| Project | IEEE 802.16 Broadband Wireless Access Working Group < http://ieee802.org/16 > | |
| Title | MS contention-based ranging and automatic adjustments with transparent RS attached to a superordinate nontransparent RS under centralized scheduling | |
| Re: | IEEE 802.16j-07/043: "IEEE 802.16 Working Group Working Group Letter Ballot #28" | |
| Purpose | Text proposal for 802.16j Draft Document. | |

Figure 1 Current scenario

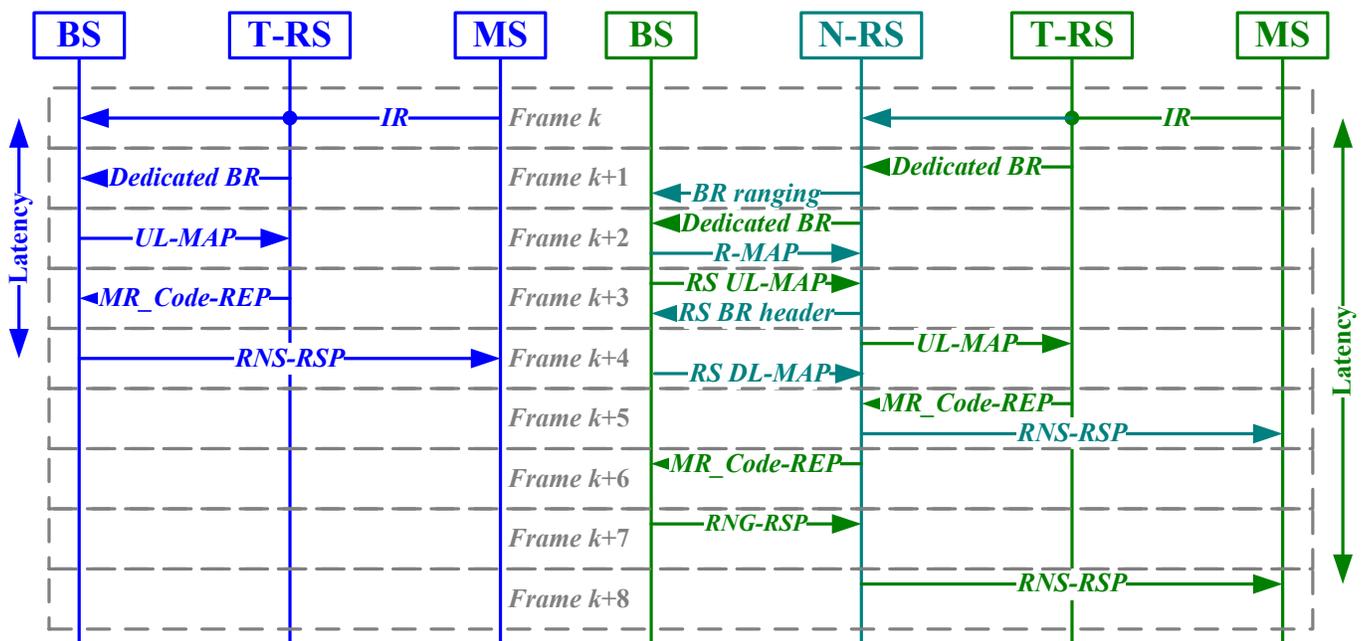
However, a subordinate transparent RS attached to a superordinate non-transparent RS under centralized scheduling cannot handle MS contention-based ranging and automatic adjustments. If the ranging code is received by both subordinate transparent RSs and superordinate non-transparent RS, the transparent RSs must request uplink bandwidth to send MR_Code-REP message to MR-BS, whereas the non-transparent RS must request downlink bandwidth to broadcast RSG-RSP message to MSs. As a result, the MR-BS will compare measured signal information at each transparent RS to decide the most appropriate path to communicate with the code originating MS but will also allocate downlink bandwidth for non-transparent RS broadcasting RNG-RSP message. Hence, the decision at the MR-BS will be incorrect. (see Figure 1)

Figure 2 Proposed scenario

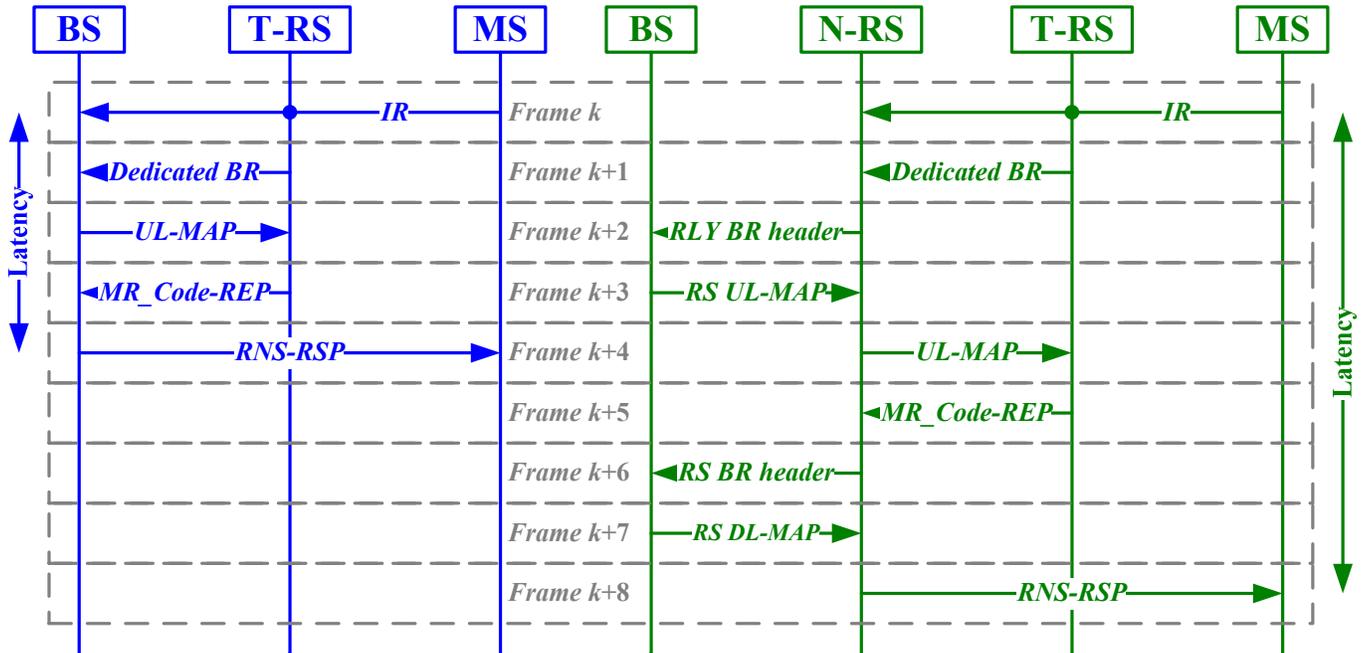
Therefore, we propose a solution described as follows (see Figure 2). If the ranging code is received by both subordinate transparent RSs and superordinate non-transparent RS, the transparent RSs must request uplink bandwidth to send MR_Code-REP message to the non-transparent RS. As a result, the non-transparent RS will compare measured signal information at each transparent RS to decide the most appropriate path to communicate with the code originating MS. Then, the non-transparent RS must request downlink bandwidth for broadcasting RNG-RSP message.

Figure xxx-a—Handling CDMA ranging code at a subordinate transparent RS

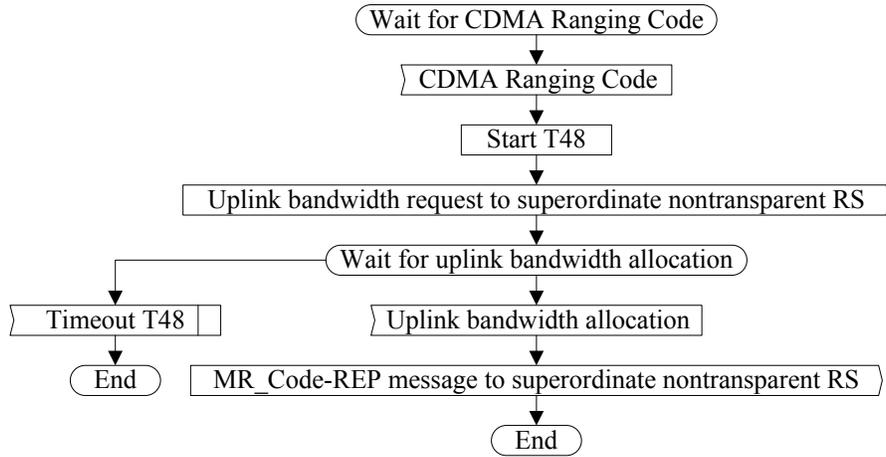
The CDMA ranging code may be received by the superordinate nontransparent RS and some subordinate transparent RSs near the MS. The subordinate RSs receiving the initial ranging code with sufficient signal quality shall transmit an MR Code-REP message containing ranging code attributes and adjustment information to the parent nontransparent RS with the RS basic CID. When a subordinate RS receives multiple codes in a frame, the RS should send an MR Code-REP message containing information of multiple received ranging codes.

The message flow charts in Figures xxx-a, xxx-b describe the ranging and adjustment process that shall be followed by compliant RSs and MR-BSs.

Figure xxx-b—Handling CDMA ranging code at a superordinate nontransparent RS

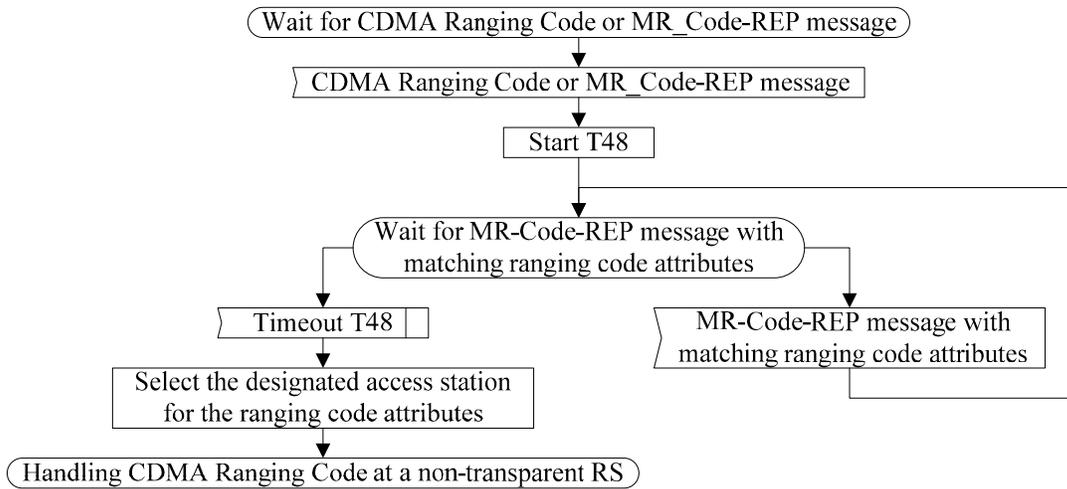
When the superordinate RS receives CDMA ranging code or MR Code-REP message containing CDMA ranging code with RS basic CID at the first time, it shall wait for MR Code-REQ message with the same ranging code from its subordinate RSs for T48 timer. Once T48 timer expired, the superordinate RS shall compare measured signal information at each station to decide the most appropriate path to communicate with the code originating MS, according to channel measurement information. Algorithms to select a path are out of scope of this document. Then the superordinate RS shall follow sequence described in MS contention-based ranging and automatic adjustments with non-transparent RS, where the RNG-RSP message shall contain adjustment information associated to the selected access RS, if present.
